Interim Response to ADEM Comments, July 30, 2018 Downtown Environmental Assessment

PREPARED FOR: Samantha Downing/Alabama Department of Environmental Management (ADEM)

PREPARED BY: Downtown Environmental Alliance (DEA) Technical Committee

DATE: September 28, 2018

FIGURE 1
 PCE Groundwater Results - July 2016
 Risk Assessment/Alternatives Analysis Report
 Downtown Environmental Assessment Project
 Montgomery, AL

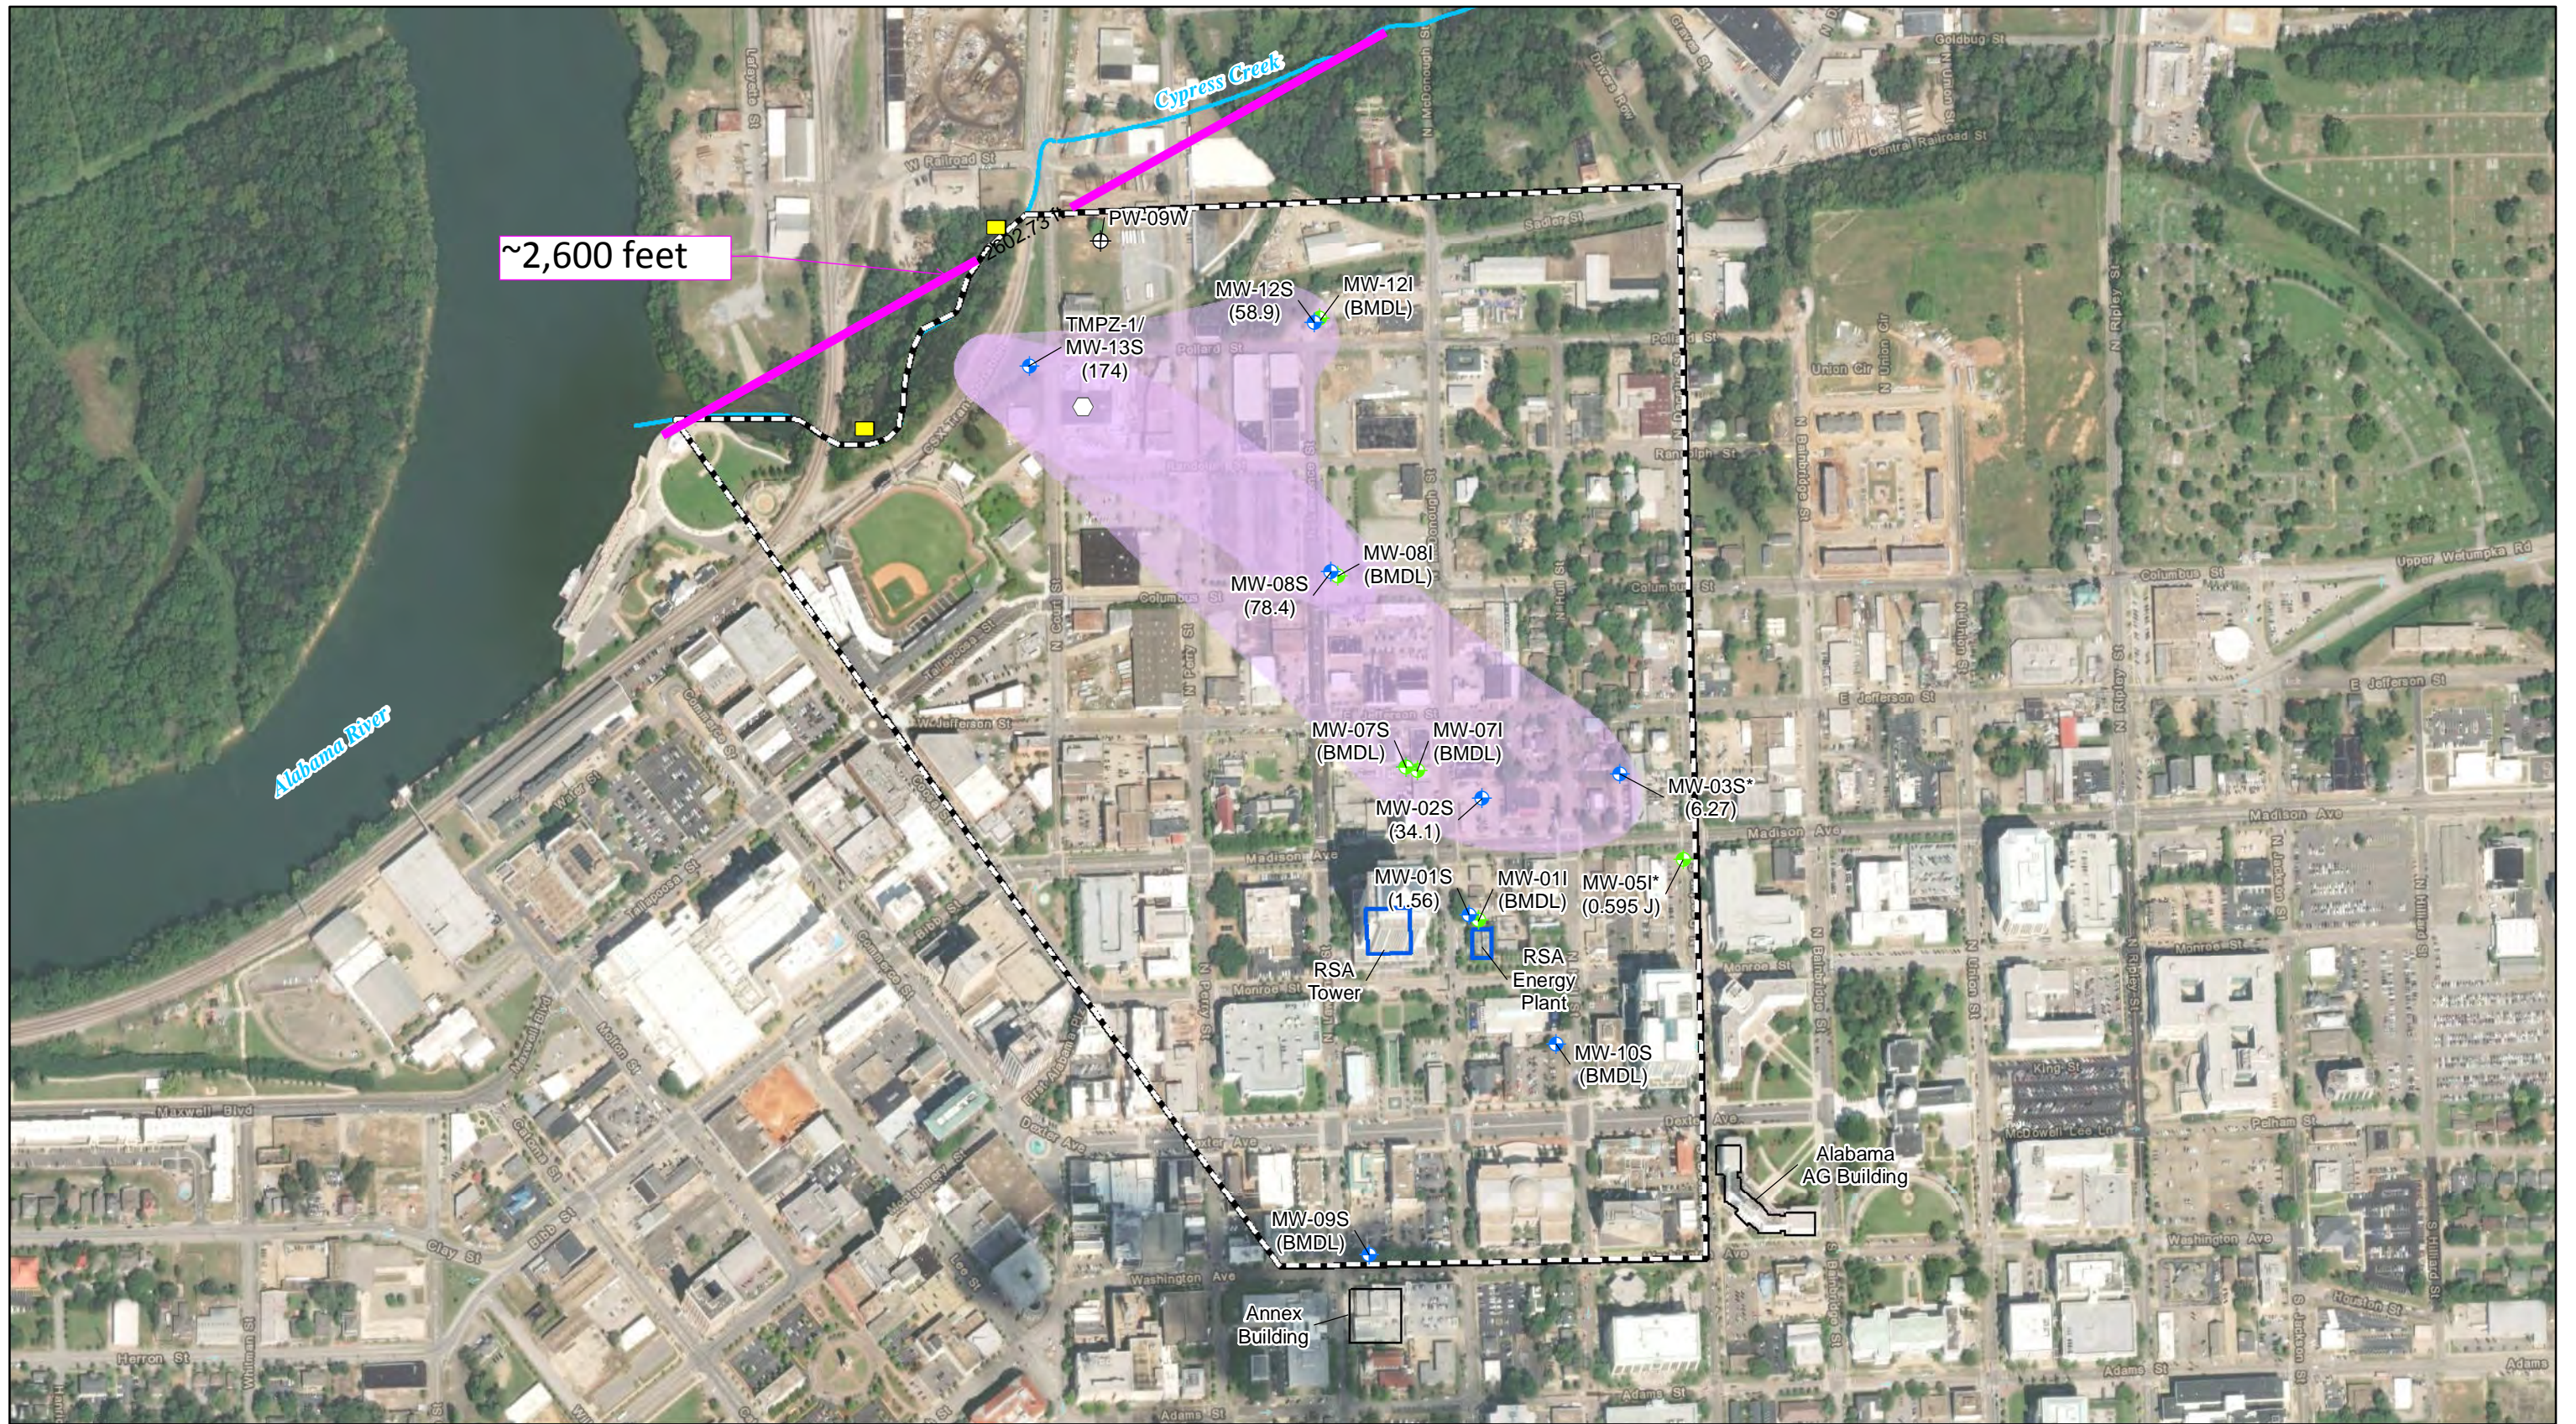
- The discharge length of the plume used in the dilution attenuation factor (DAF) calculations is based on data that are over 10 years old. In addition, the conceptual site model (CSM) indicates that the Alabama River acts as a hydraulic barrier at the leading edge of the plume. Therefore, ADEM requested that the DEA consider the possibility that the plume may have spread over time and the estimated discharge length in the DAF calculations may be assumed to be too narrow. Please evaluate how changes in plume discharge length impact the DAF estimate.

To estimate the impact of plume discharge length on the DAF calculations and estimated concentrations of tetrachloroethene (PCE) in Cypress Creek, the discharge length of the plume, which is assumed to interact with pore water, was increased to a nearly 0.5 mile (2,600 feet) as shown on Figure 1. The incremental increase of the discharge length and calculated percent decrease in the DAF are presented in Table 1. The results of the evaluation indicate that changes in DAF are more sensitive when the discharge length is smaller and less sensitive as discharge length assumptions increase, as follows:

FIGURE 2
Conceptual Exposure Model
 Risk Assessment/Alternatives Analysis Report
 Downtown Environmental Assessment Project, Montgomery, Alabama

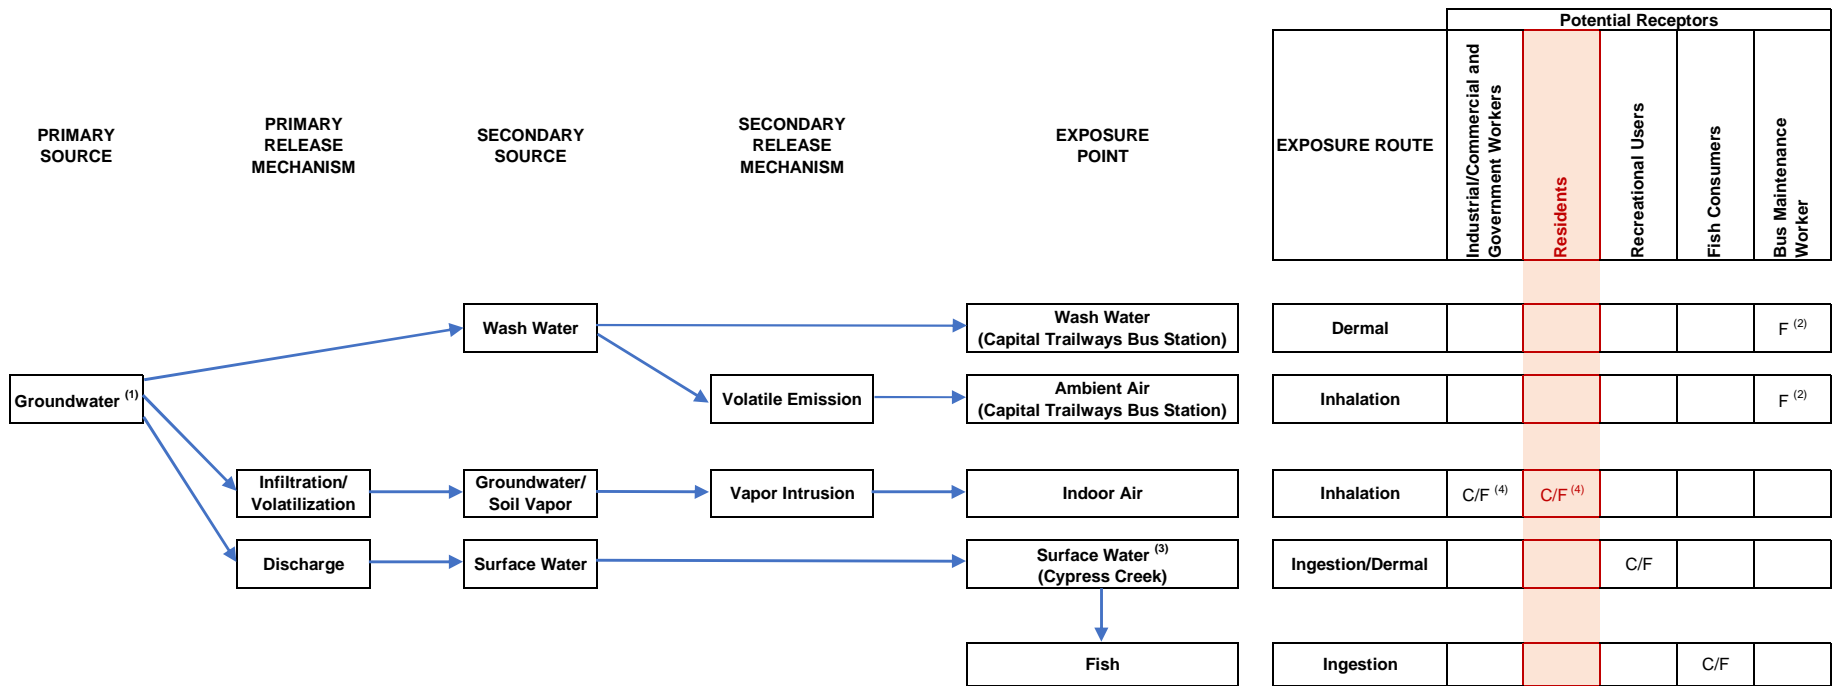
- The human health risk assessment (HHRA) currently identifies the drinking water pathway as incomplete because the former municipal supply wells near downtown have been abandoned and there is a “no drill” ordinance for the downtown area. ADEM noted that their policy is to consider the drinking water pathway complete and carry it through the risk assessment.

In addition to the above comments provided by ADEM, after the preparation of Draft RA/AA Report, the DEA was notified during a July 2018 Community Outreach Group meeting, that a downtown commercial property is currently being used as an apartment, which is residential use.

The conceptual exposure model has been updated (Figure 2 and Table 3) to reflect the presence of potential residential properties within the DEAP site under current and future conditions; this will be incorporated into the revised Final RA/AA Report after DEA receives final comments from ADEM's review of the report. The soil vapor data used in the HHRA were screened using the EPA Vapor Intrusion Screening Levels (VISLs) for a residential scenario. A commercial scenario is not evaluated in this technical memorandum because it was evaluated in the Draft RA/AA Report.
